**RE: Geotechnical Peer Review Response Letter
Parkland Heights Plat
4929 Issaquah-Pine Lake Road Southeast
Issaquah, Washington
RGI Project No. 2021-129-1**

Reference: The Riley Group, Inc Geotechnical Engineering Report, MacLean Property Plat, Issaquah, Washington dated June 30, 2021 and Slope Setback Exemption Letter, MacLean Property Plat, Issaquah, Washington dated March 31, 2022

The Riley Group, Inc. (RGI) is pleased to provide this letter addressing the Geotechnical peer review comments prepared by Golder dated November 3, 2022. RGI previously prepared the referenced Geotechnical Engineering Report (GER) and Slope Exemption Letter for the plat. The review comments are provided, followed by our responses.

Title:
GRADING PLAN
OFFSITE

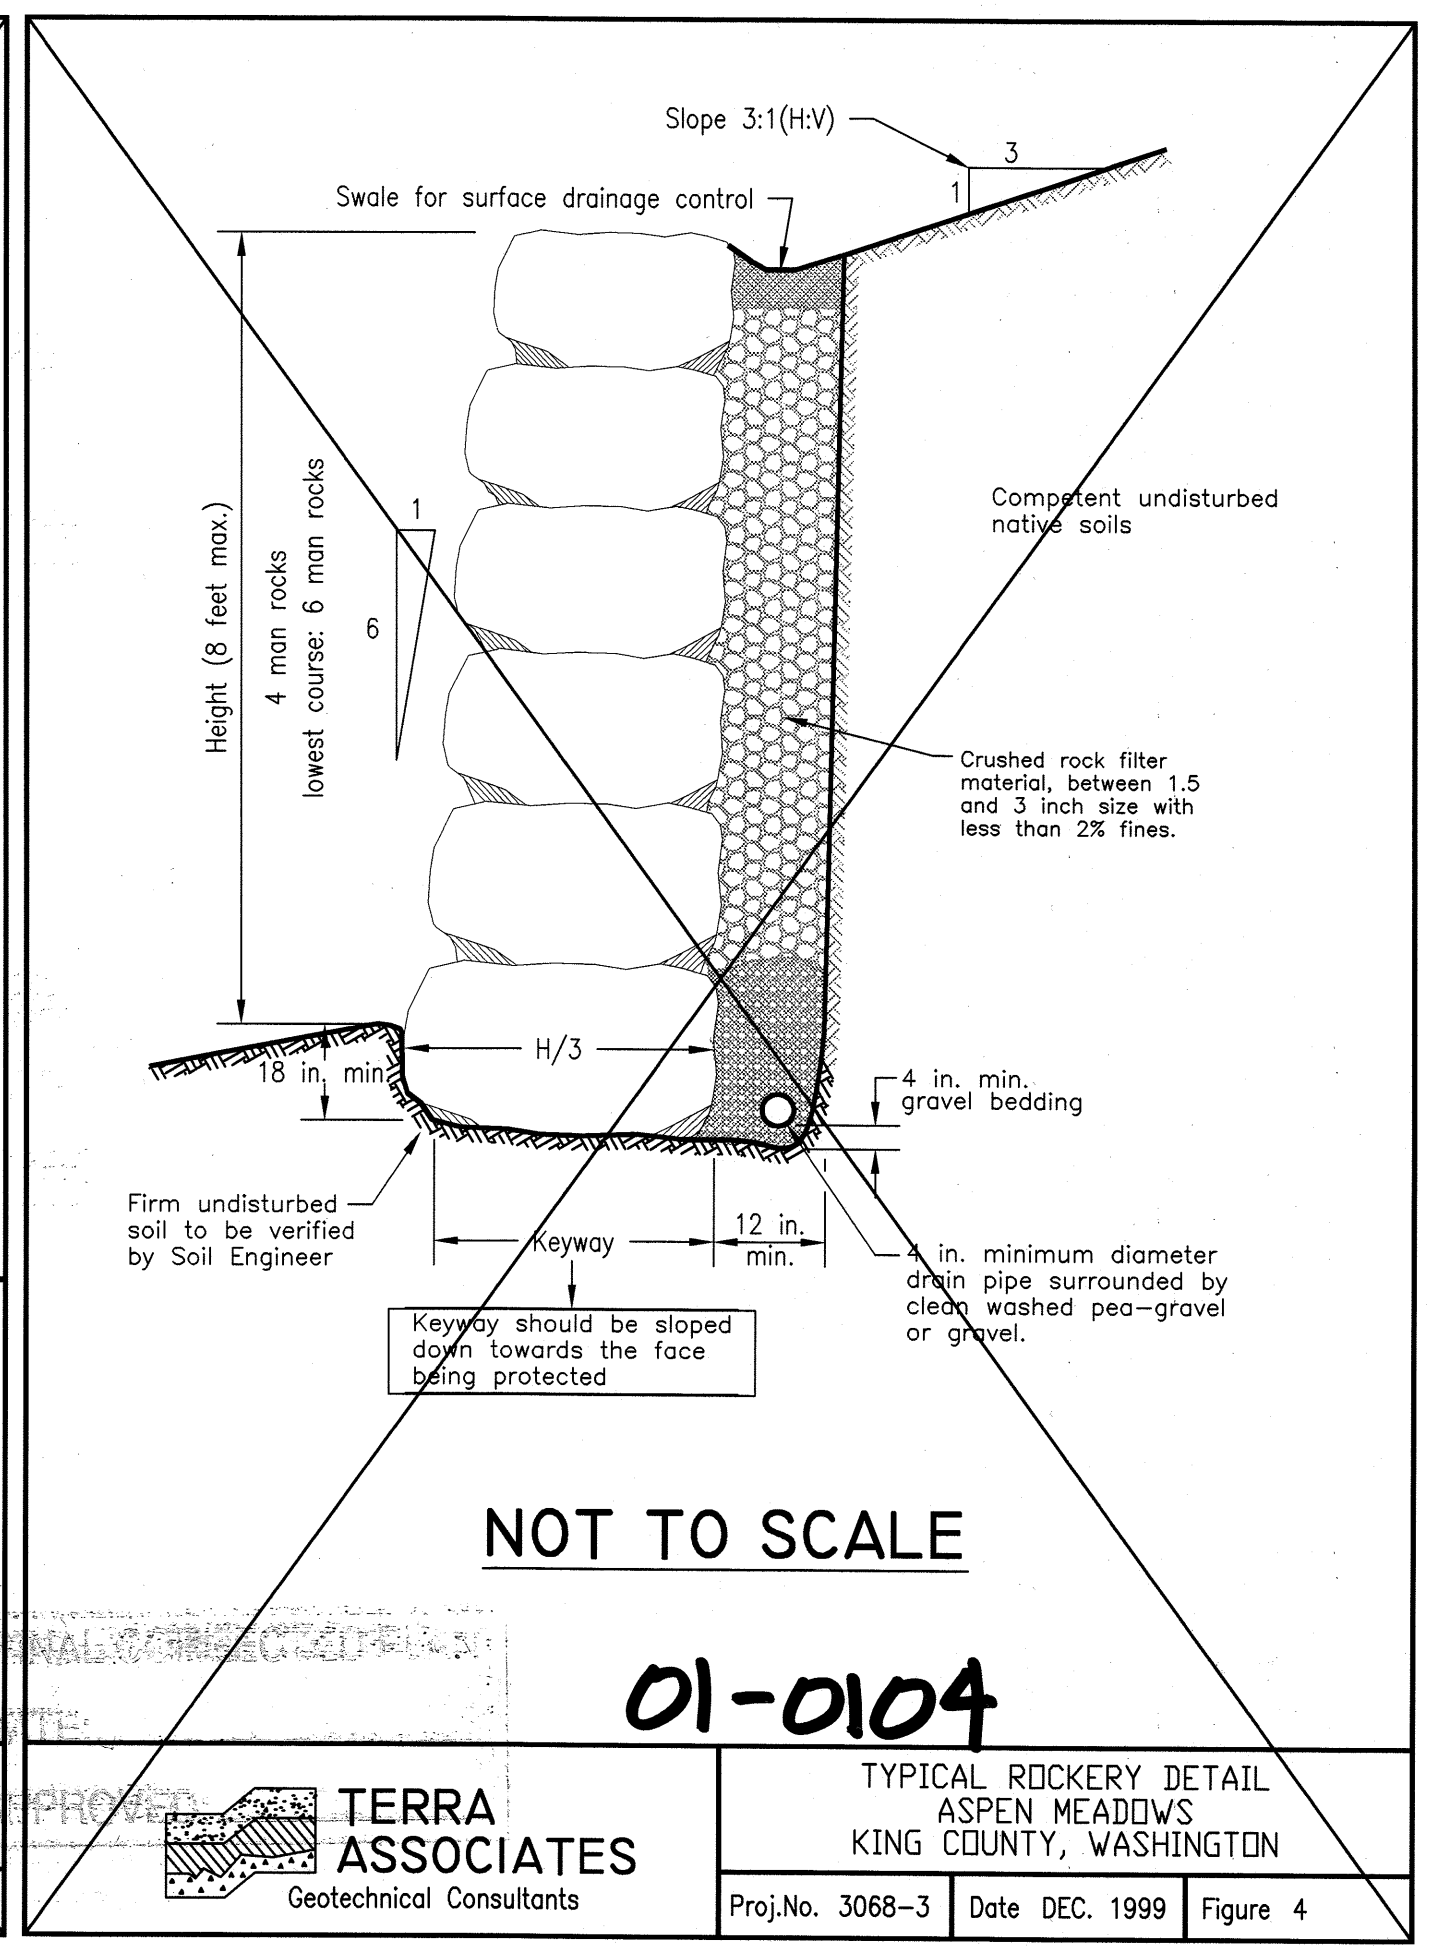
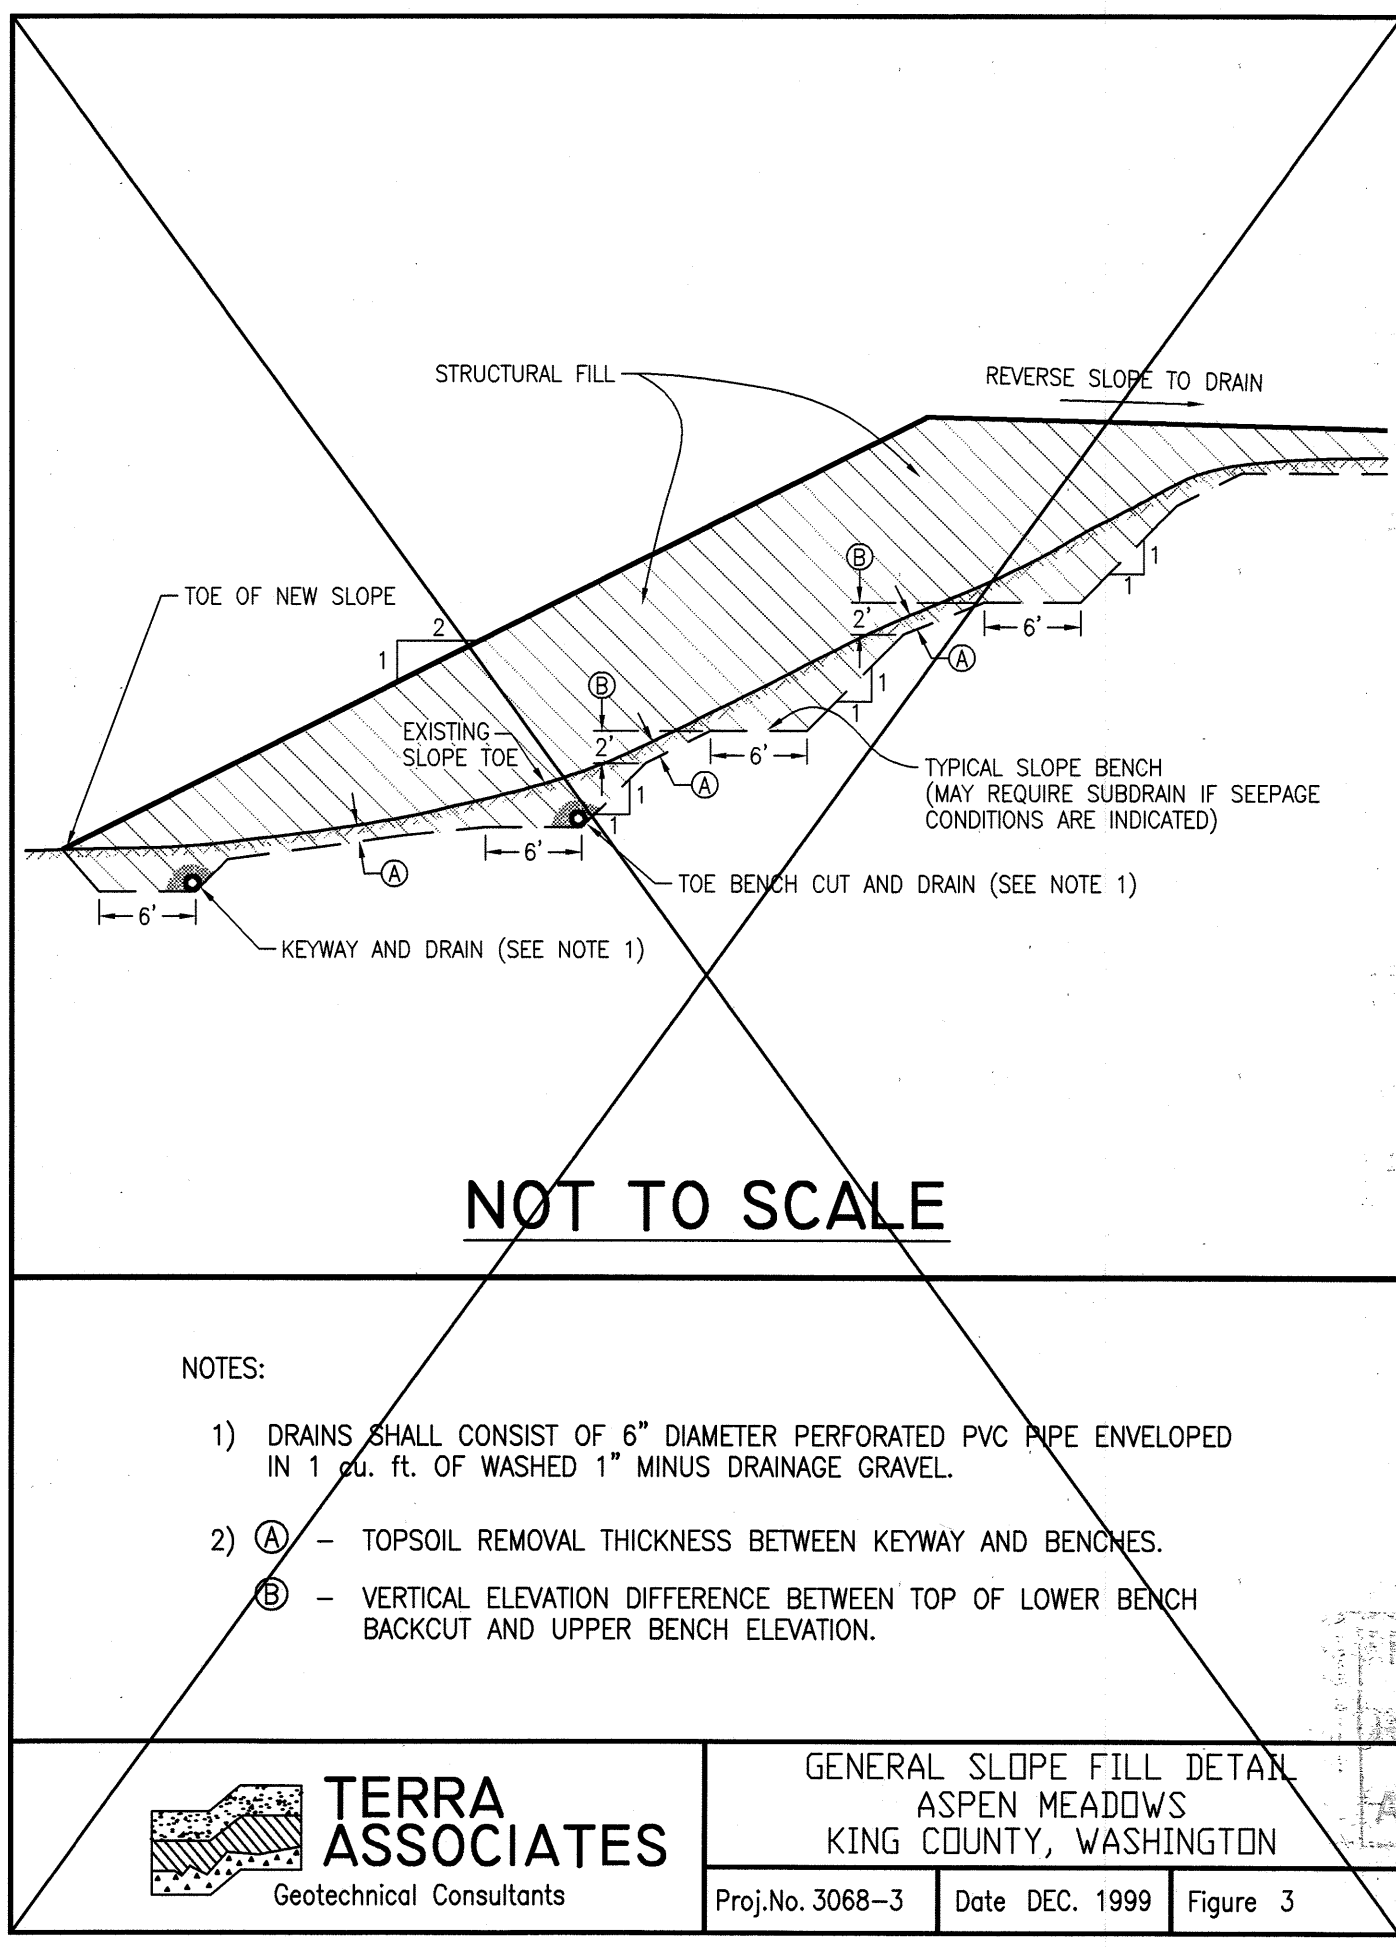
Comment #2: The Geotechnical Letter states that the slopes along Issaquah-Pine Lake Road and Southeast 48th St were created by grading the road and are cut into bedrock. In addition, Section 4.6.1 of the Geotechnical Report states that the steep slope areas “appear to have been created by roadway and pond cuts...” Although it appears logical that the road cuts created the steep slopes, there is no evidence submitted in the package for the reviewer to verify these claims.

Please provide evidence to support these claims, such as pre-construction and post-construction topography maps of the steep slopes, aerial imagery, field observations and physical evidence etc.

RGI Response #2: Review of USGS mapping from 1950 show that Issaquah-Pine Lake Road Southeast was not straight, and was located a distance east of the eastern property line. Currently, the road cuts are located at the eastern property line, with the straightened Issaquah-Pine Lake Road Southeast near the toe. Overlapped USGS maps from 1950 and 2020 with Issaquah-Pine Lake Road Southeast locations are shown on Figure 1. Reconnaissance of the road cut along Issaquah-Pine Lake Road Southeast shows bedrock exposed in the cut face at several locations in the lower portion of the cut. A photo of exposed bedrock is shown on Figure 2. The Grading plan for Aspen Meadows showing the grading for Southeast 48th Street is attached to this letter.
